# PARTS & SERVICE NEWS

REF NO.	A930038
DATE	Mar. 19, 1993

**SUBJECT:** REPAIR OF THE COVER PLATE IN THE REAR FRAME

**APPLICATION:** WA700-1 Wheel Loaders, Serial Nos. 10001 thru 10093

Figure 1 Bulkhead between the transmission housing and the engine room as viewed from the machines rear side.

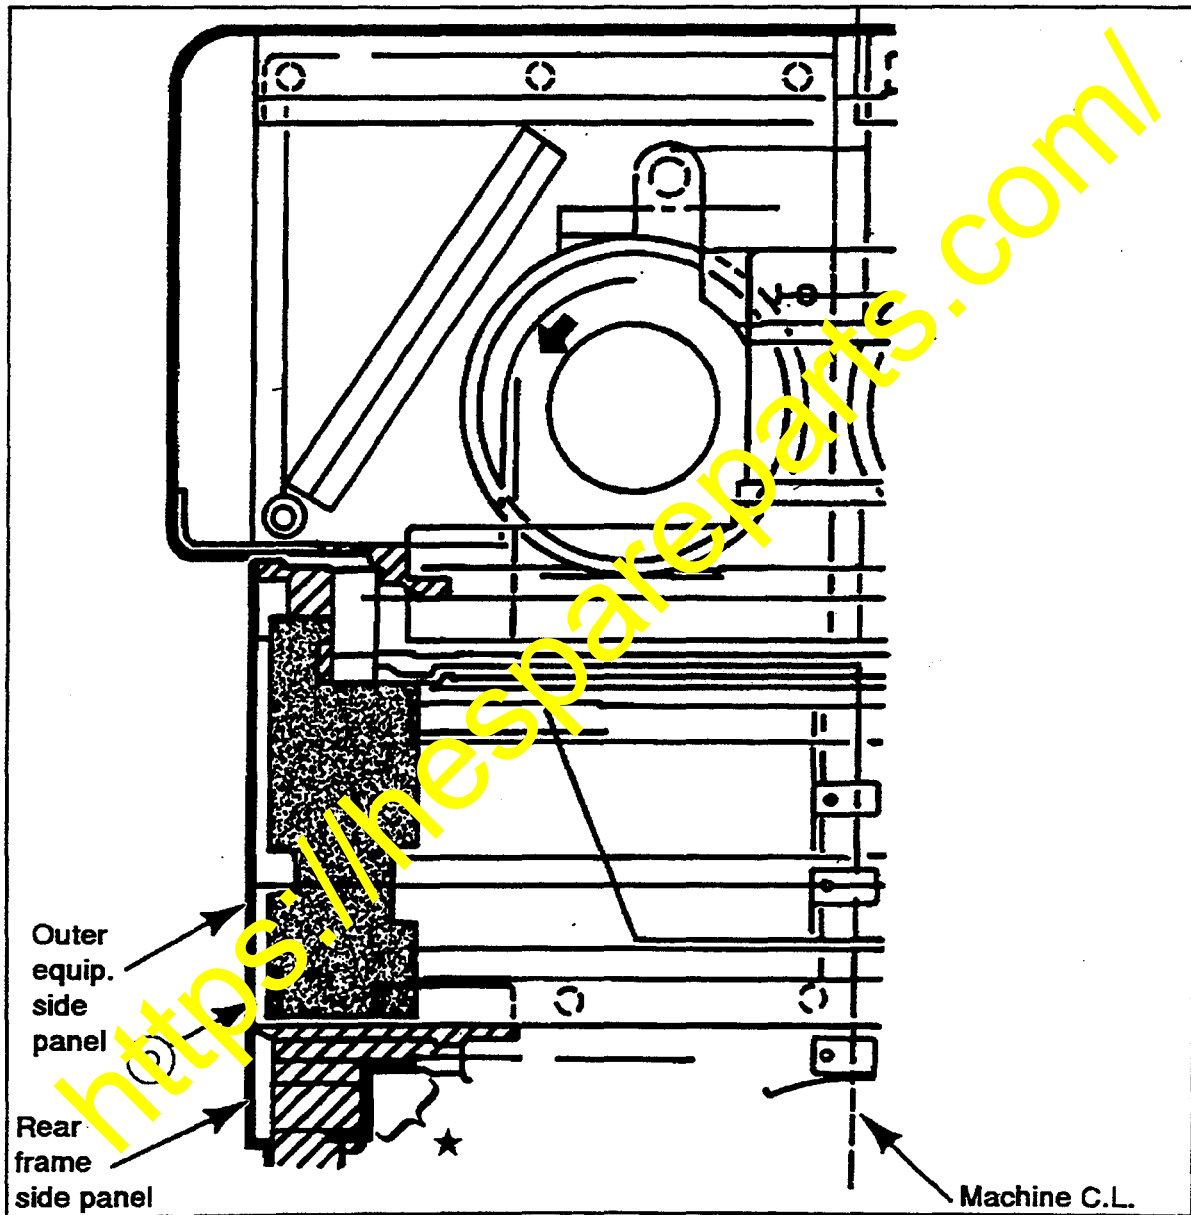
- (1) Add a rubber baffle to cover the opening (the portion marked ★ between the frame and the existing bulkhead) at the leftside lower end of the bulkhead.
- (2) Cover the opening (marked ⊙) by extending the existing rubber baffle lower part.

Fig. 2

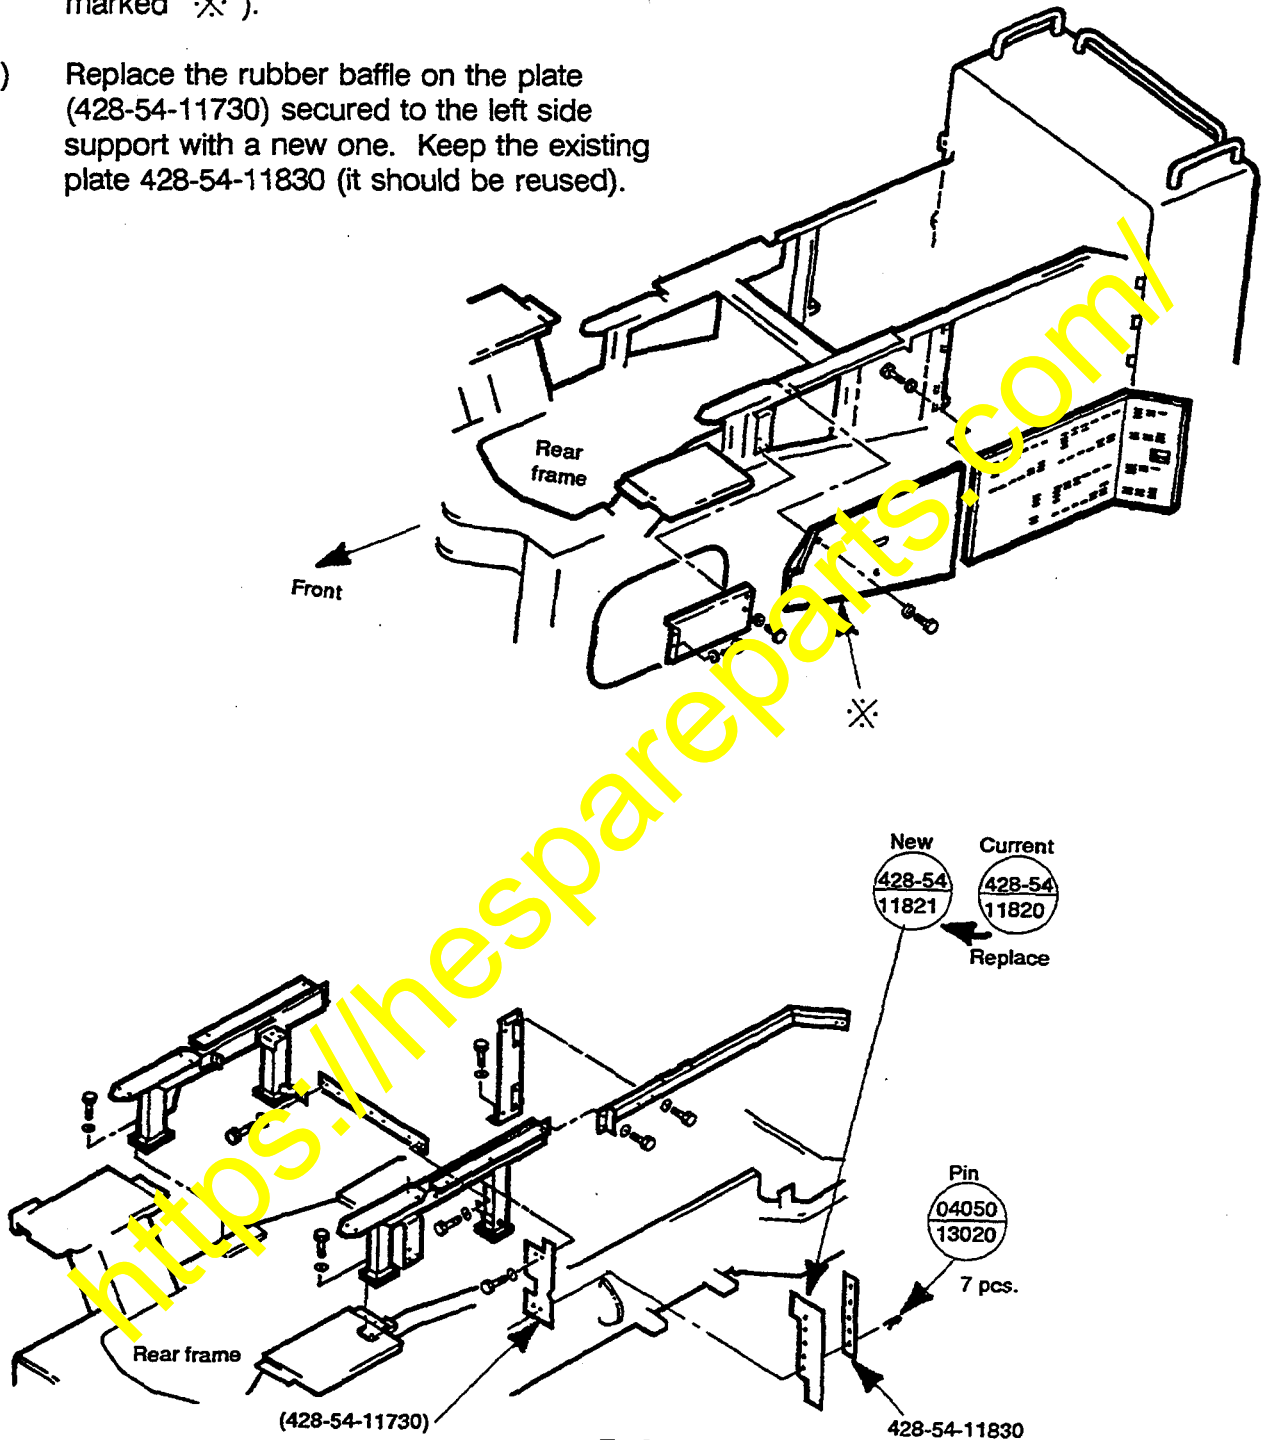
- (1) Remove the engine room side panel marked ✕ ).
- (2) Replace the rubber baffle on the plate (428-54-11730) secured to the left side support with a new one. Keep the existing plate 428-54-11830 (it should be reused).

- Identification of new rubber baffle and its installation to the machine.

**NEW:** 428-54-11821  
**CURRENT:** 428-54-11820

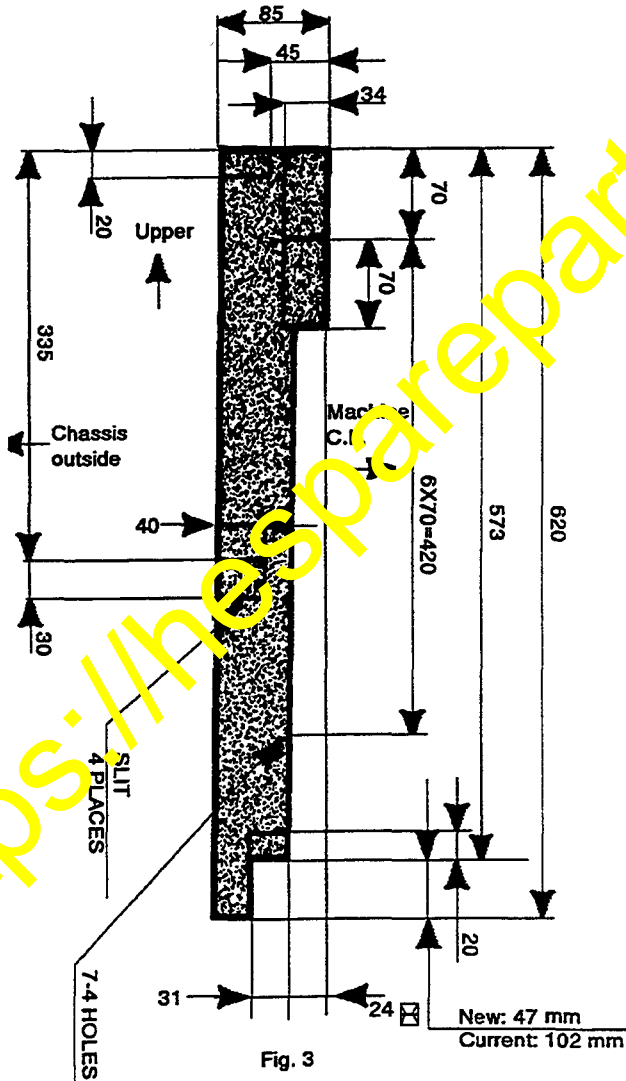
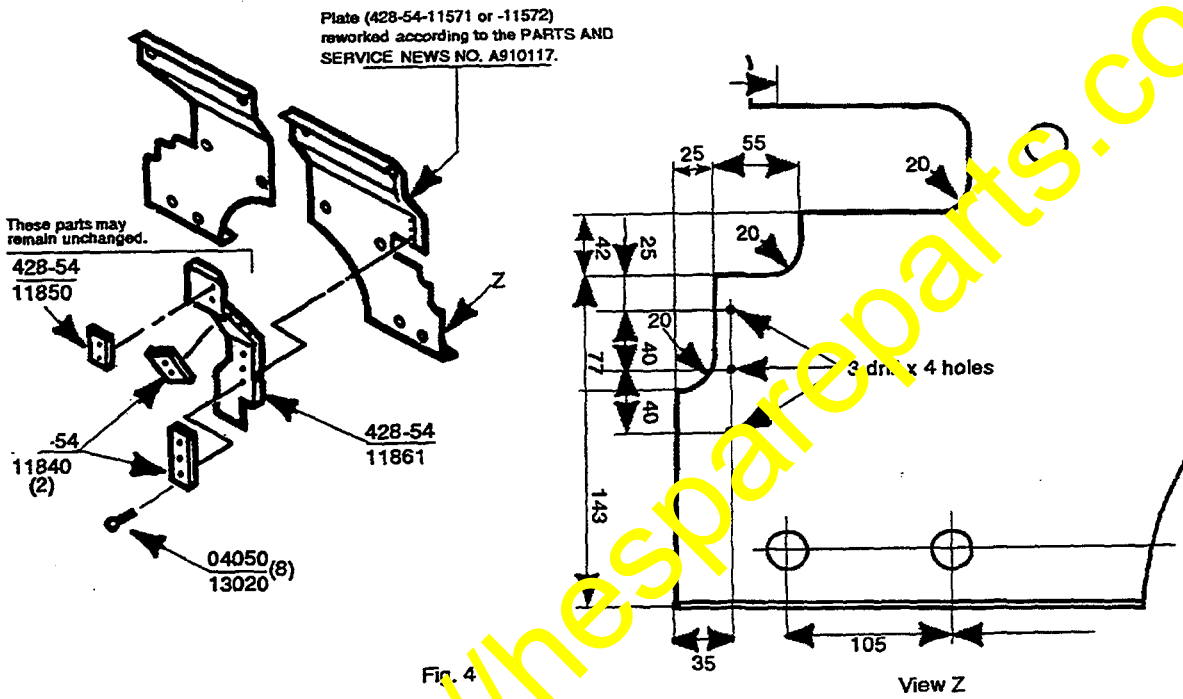
These baffles are different only in length. Refer to dimensions marked ☒ in Figure 3.

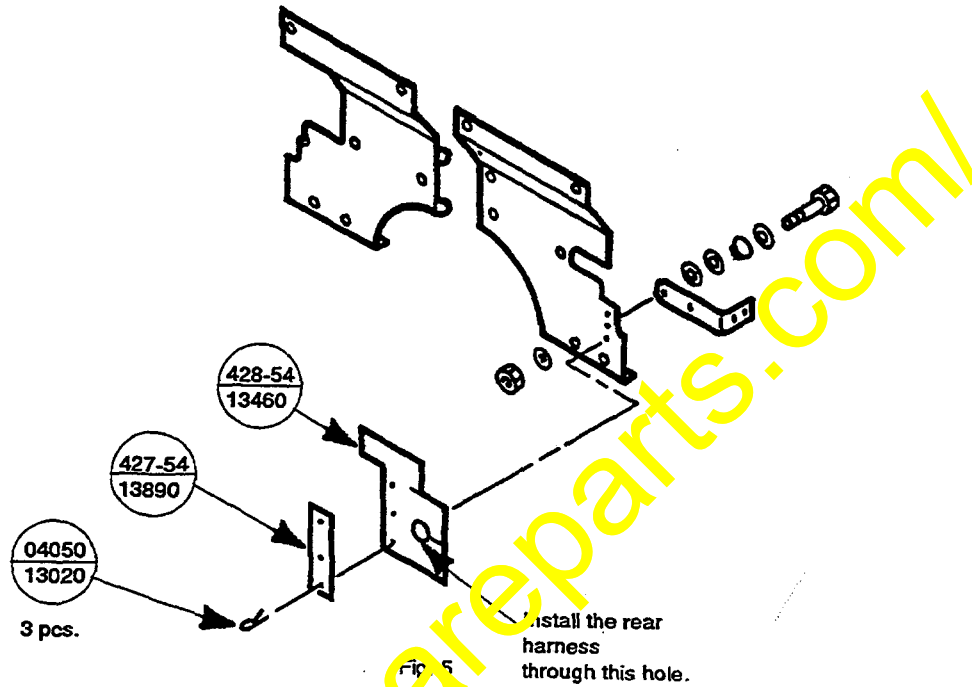
- 3) Drill additional holes into the plate on the machines left lower side as indicated below.

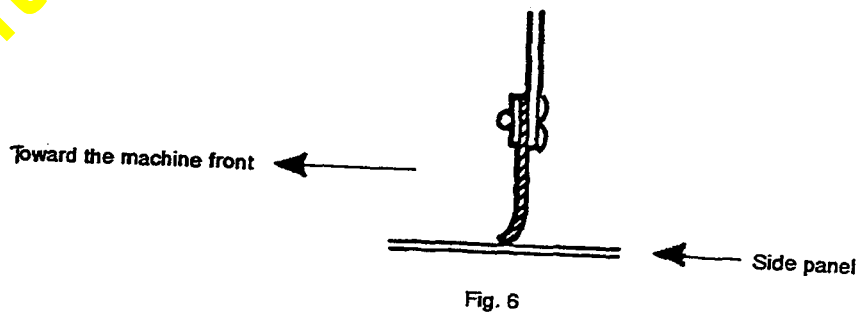
- (4) Attach the rubber baffle (428-54-13460) using the drilled holes provided in (3) above.

Fig. 7

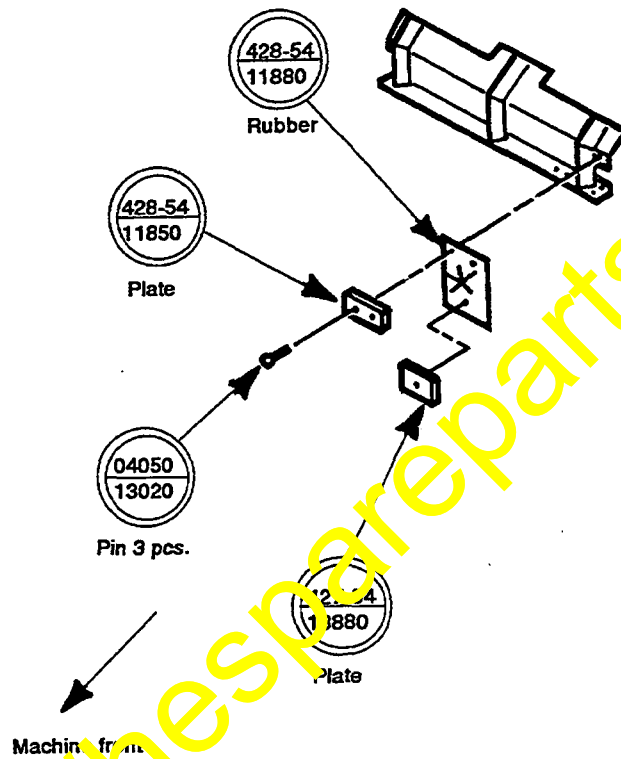
**NOTE:** On WA700-1 Machines Serial Nos. 10001 thru 10076 (excluding the Serial No. 10065), the rubber baffle (shown in Figure 7) has been installed on the bulkhead according to the Parts & Service News A910117. Check such baffles for complete sealing at the bulkheads.

If clearance exists reposition the baffle to seal properly.
